ADDENDUM 1 (PENDING DSA APPROVAL)

PROJECT: **Santa Ana College**
 Science Center

DATE: 8/23/2017

DSA File No.: 30-C2
DSA Applications No.: 04-115788
HGA Commission No.: 3584-001-00

A445

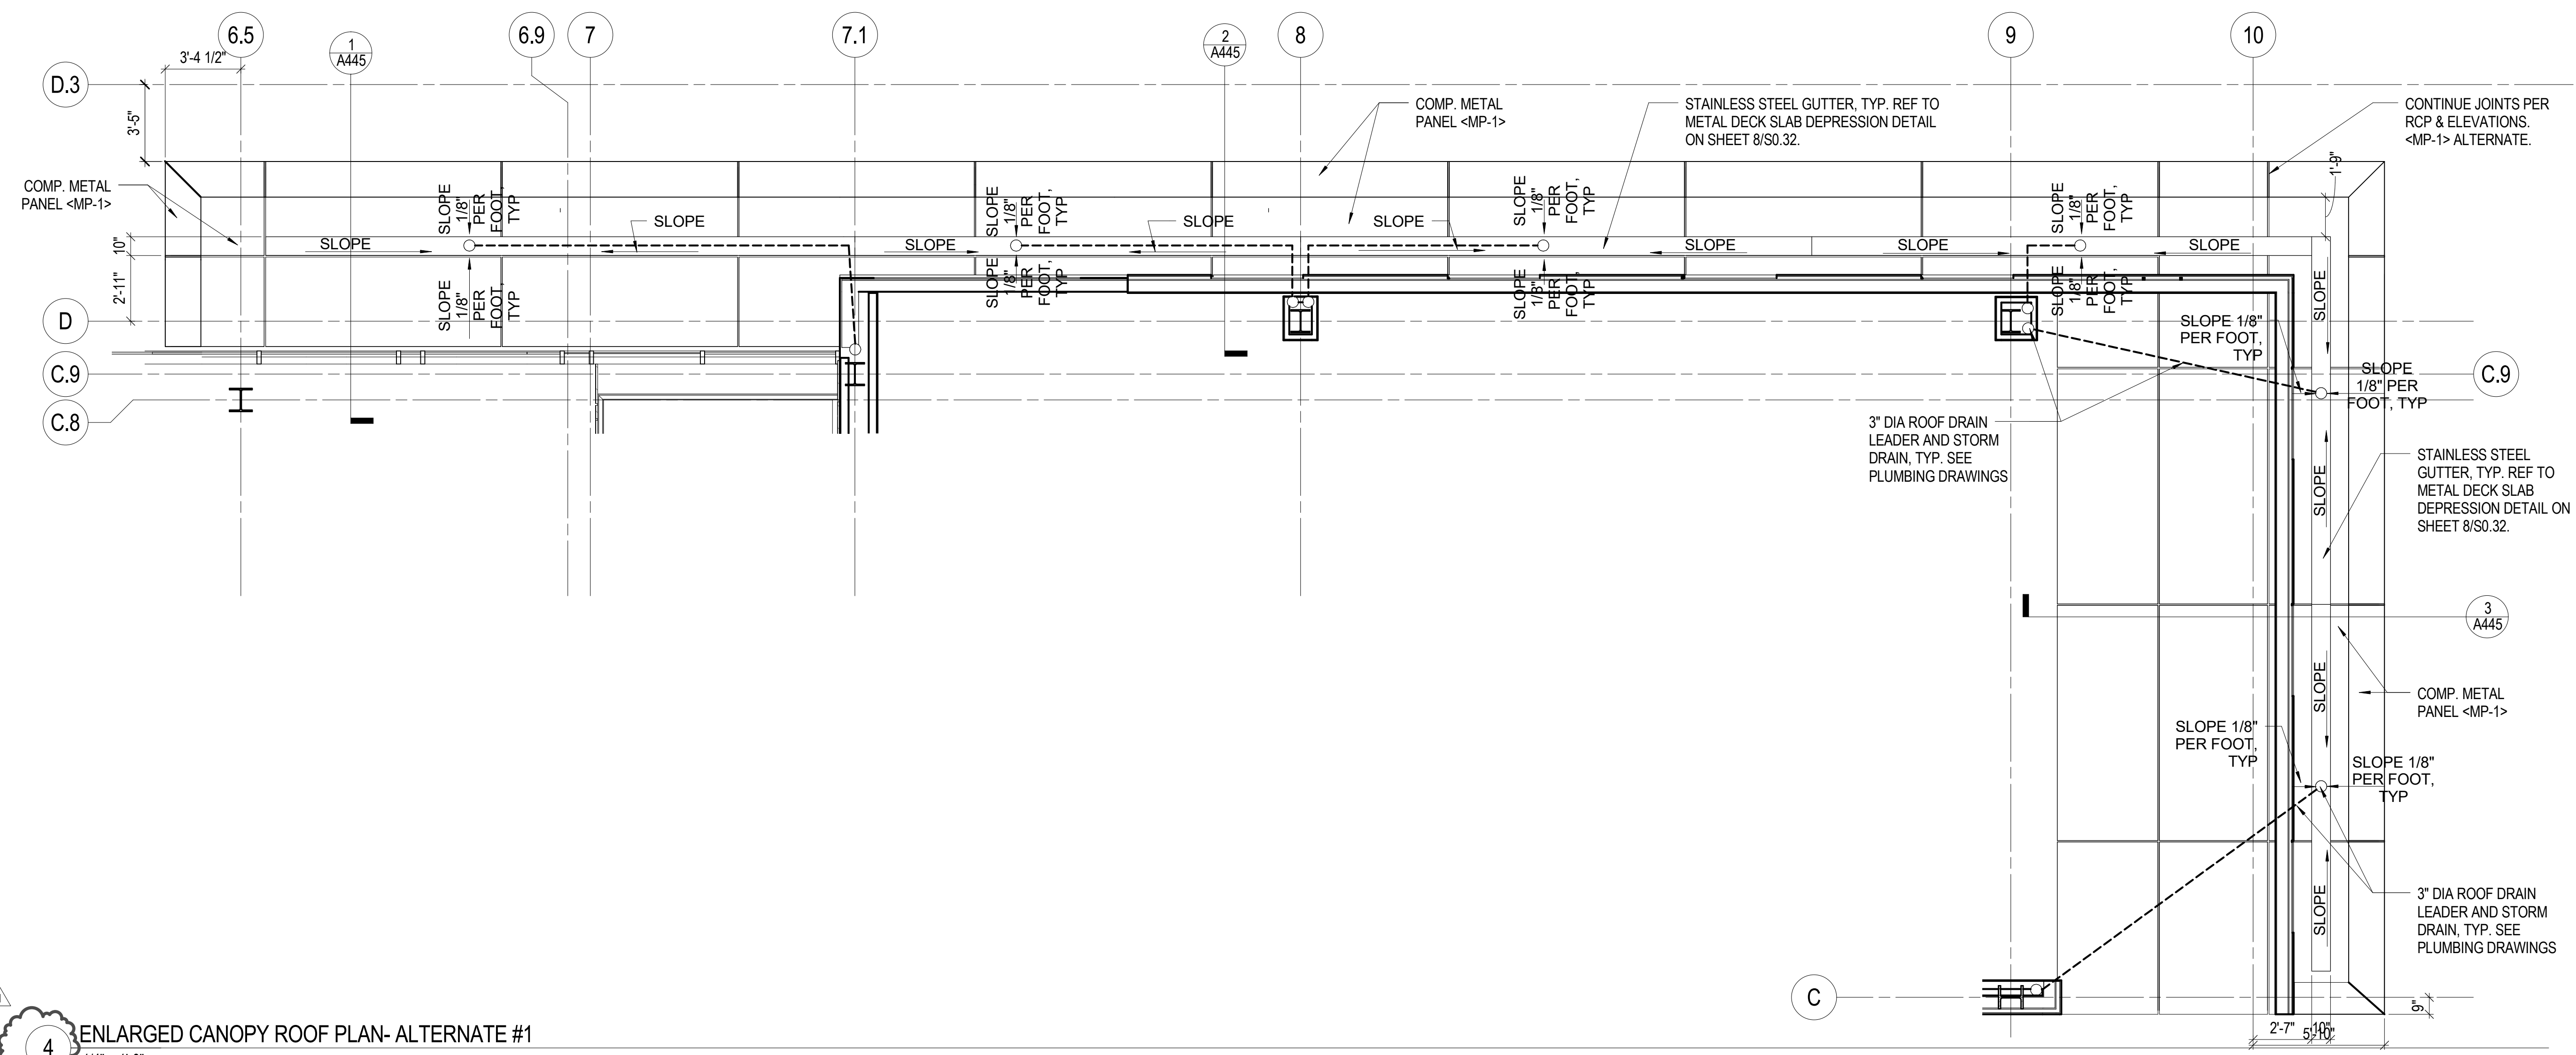
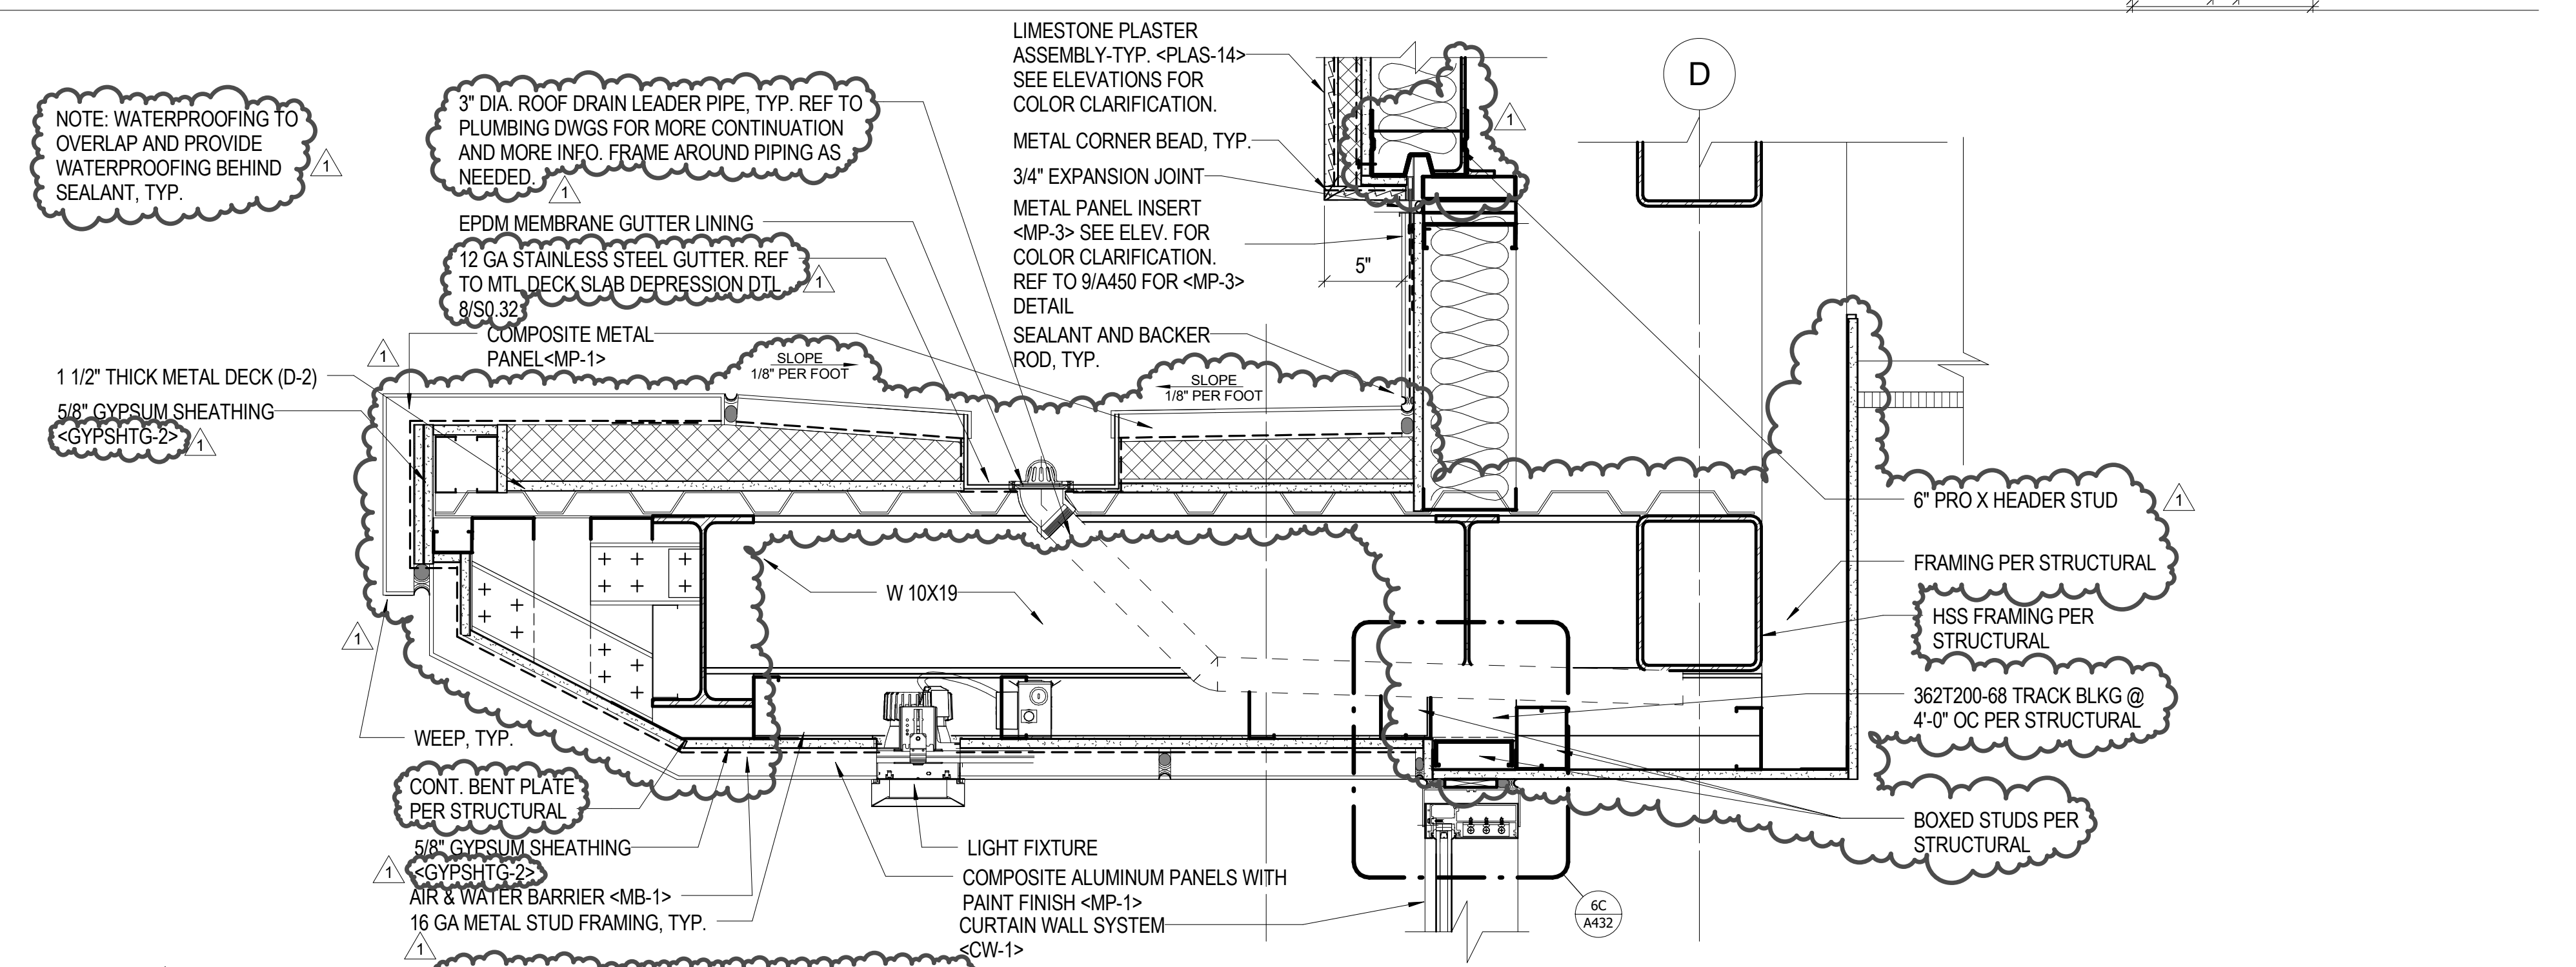
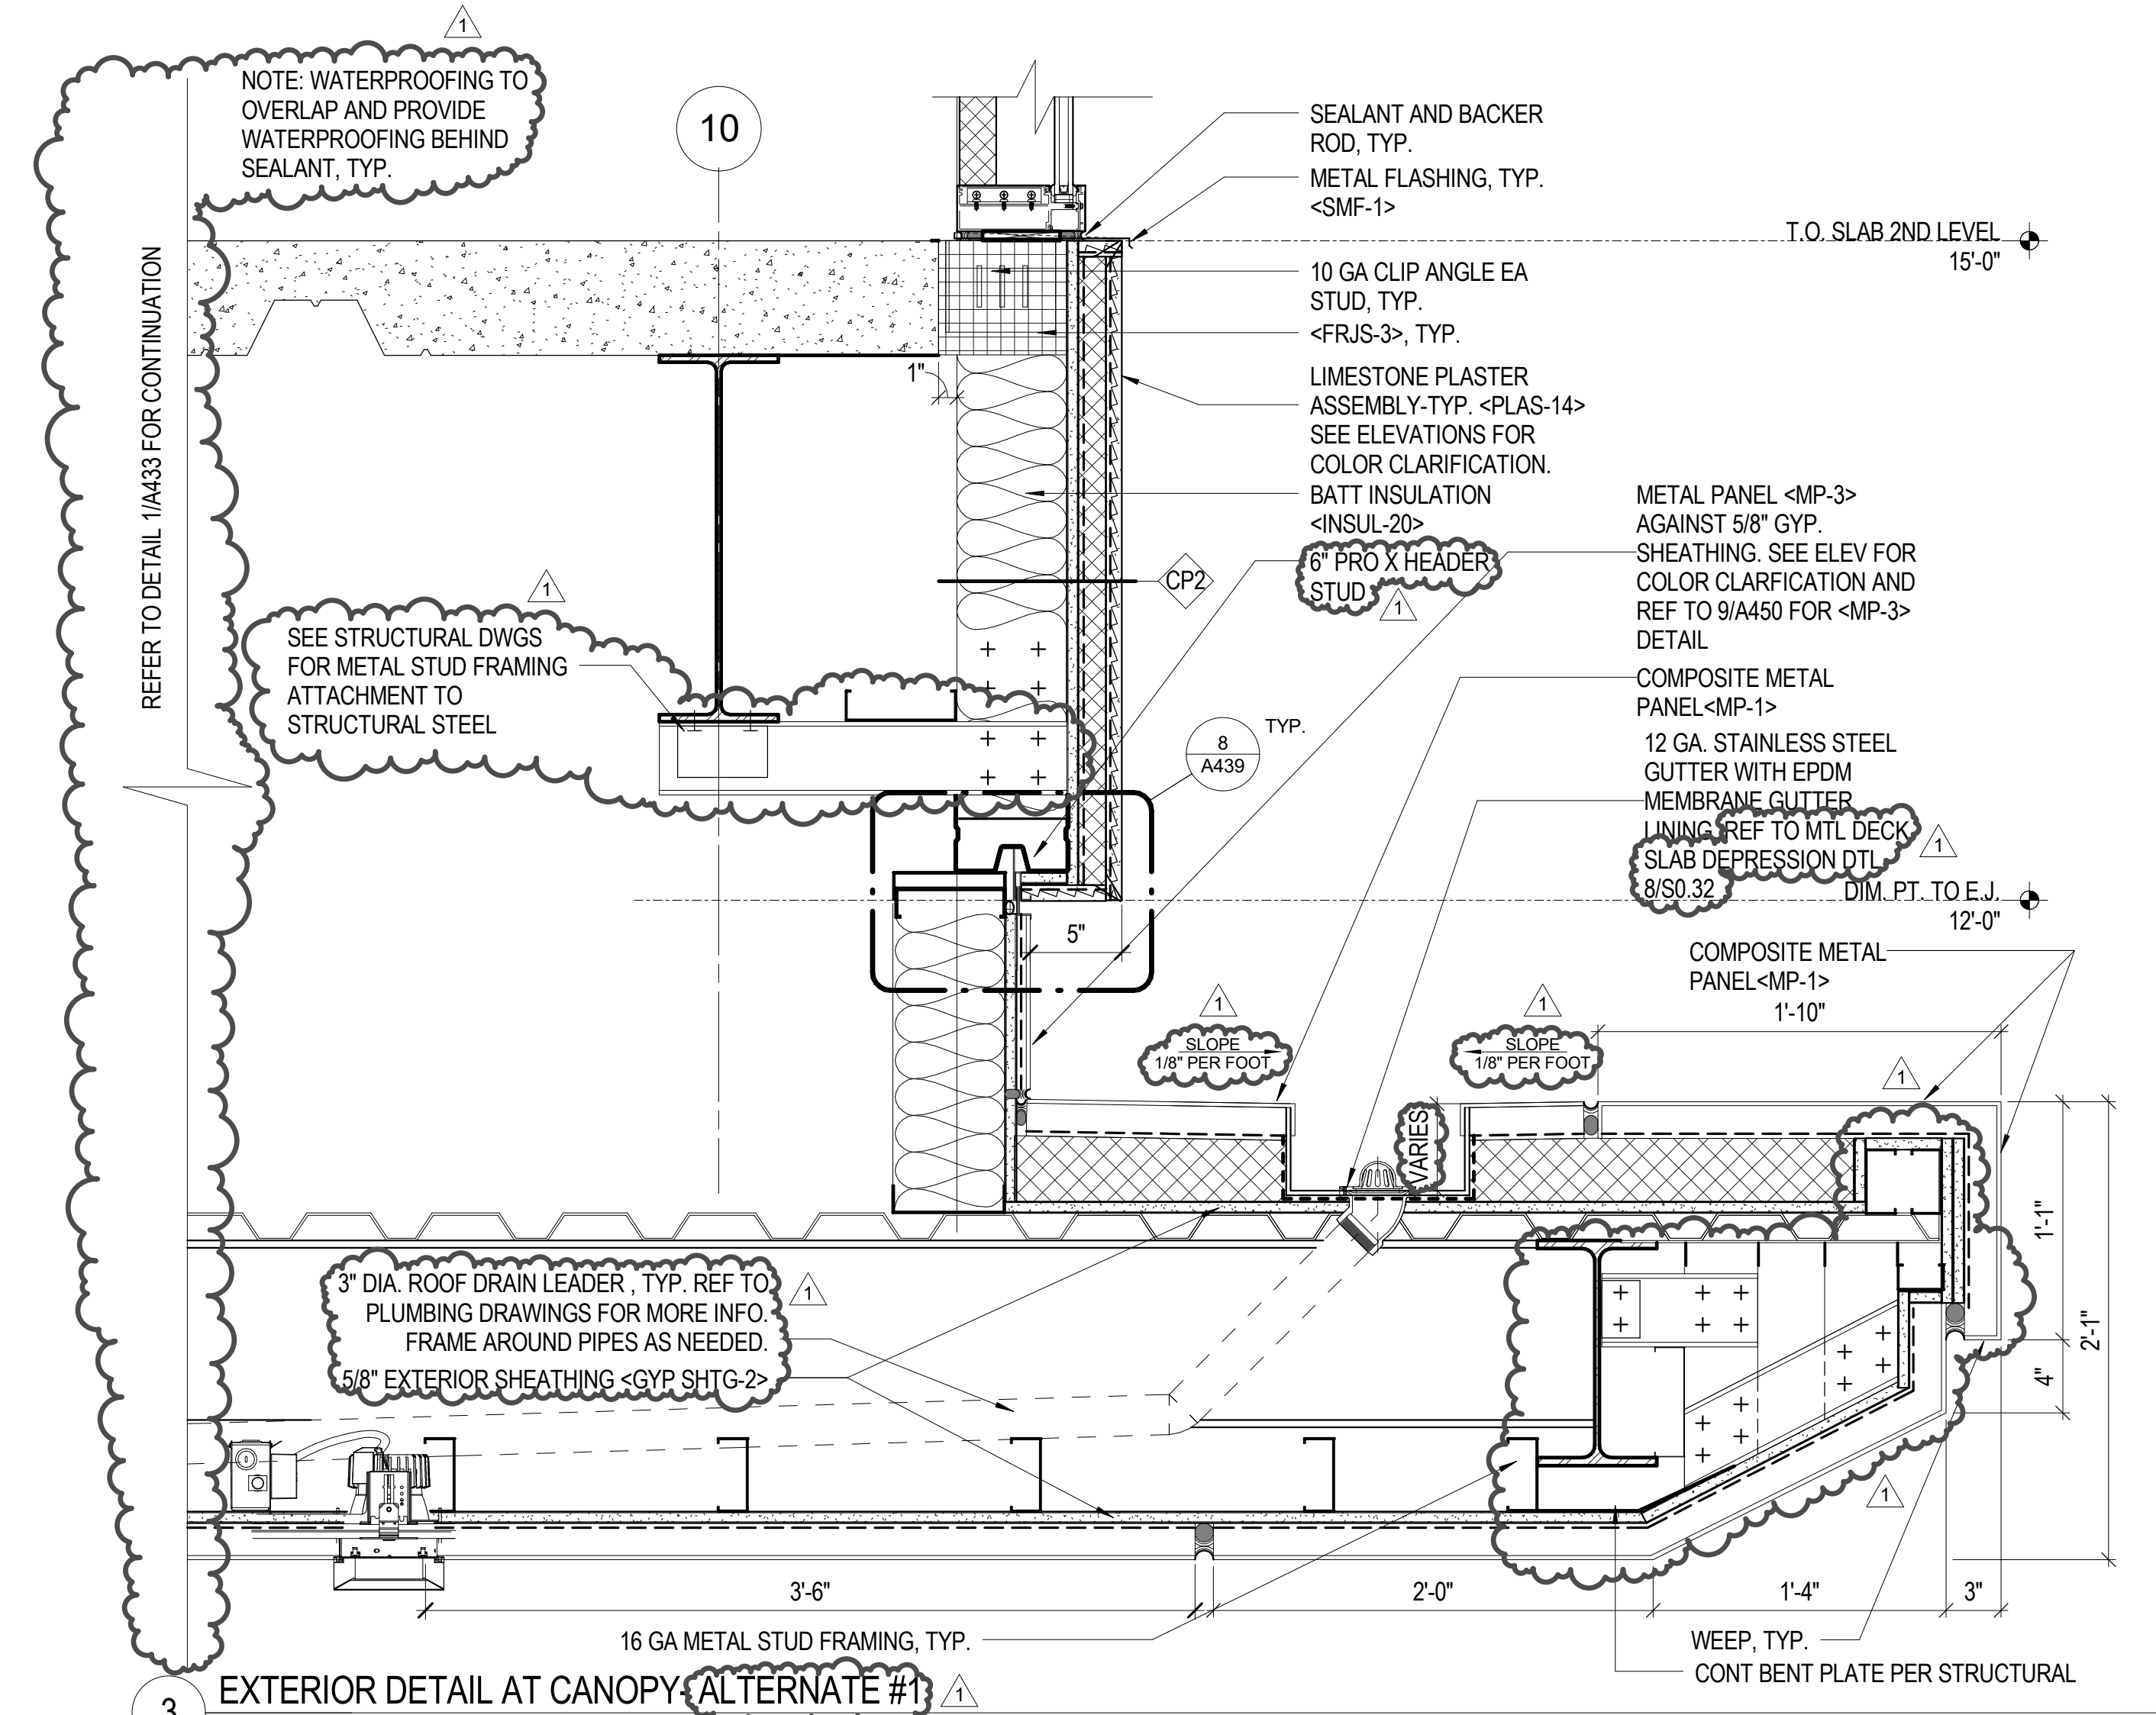
- North canopy reduced by 5'-0" at Details 1, 2, and 3.
- Framing at canopy revised to match structural drawings at Details 1, 2, and 3.
- Added detail 4, Enlarged Canopy Roof Plan- Alternate #1
